Access Compliance Report

Public Rights-of-Way

(Curb Ramps)

Intersection ID: 17986	Main Street: E_INDEPENDENCE_BV	Cross Street: DION_AV	Location: SE
ADA ID: 3BBBE4924048	Ramp Type: PerpDiag	Initial Pass/Fail: Fail	Overall Compliance: No
Codes/Mitigation Info/Possible Solution		Field Measurements/Component Compliance	
Severity Score: 22.5

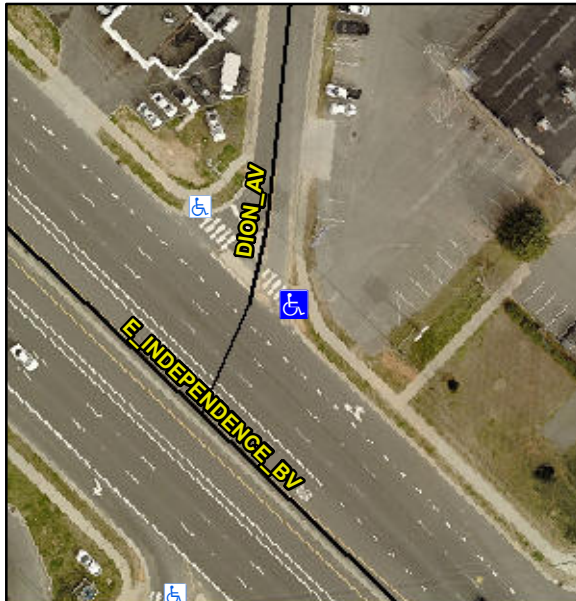
Not Found, R304.5.1, R304.2.2, R304.5.3

Compliance	Description	Data	Compliance	Description	Data
N/A	Ramp Length (in)	67.0	No	Ramp Slope (%)	8.8
No	Ramp Width (in)	47.0	No	Ramp XSlope (%)	2.9
N/A	Flare Type LT	N/A	N/A	Flare Type RT	N/A
N/A	Flare Slope LT (%)	N/A	N/A	Flare Slope RT (%)	N/A
N/A	Flare Traversable LT?	N/A	N/A	Flare Traversable RT?	N/A
N/A	Landing Length (in)	N/A	N/A	DWS Provided?	N/A
N/A	Landing Width (in)	N/A	N/A	DWS Contrast?	N/A
N/A	Landing Slope (%)	N/A	N/A	DWS Length (in)	N/A
N/A	Landing X Slope (%)	N/A	N/A	DWS Full Width?	N/A
N/A	Landing Curb? (Y/N)	N/A	N/A	DWS Offset (in)	N/A
N/A	Shared Landing?	N/A			
N/A	Gutter Ponding?	N/A	N/A	Gutter Slope (%)	N/A
N/A	Gutter Lip Ht (in)	N/A	N/A	Gutter X Slope (%)	N/A
N/A	Painted X Walk1?	Yes	N/A	Painted X Walk2?	No
	X Walk 1 Direction	To NW		X Walk 2 Direction	To SW
N/A	X Walk 1 Width (in)	108.0	N/A	X Walk 2 Width (in)	N/A
	X Walk 1 Slope (%)	2.8		X Walk 2 Slope (%)	2.0
	X Walk 1 X Slope (%)	0.8		X Walk 2 X Slope (%)	0.1

Remove & Replace Curb Ramp With Two New Directional Ramps or Equivalent.
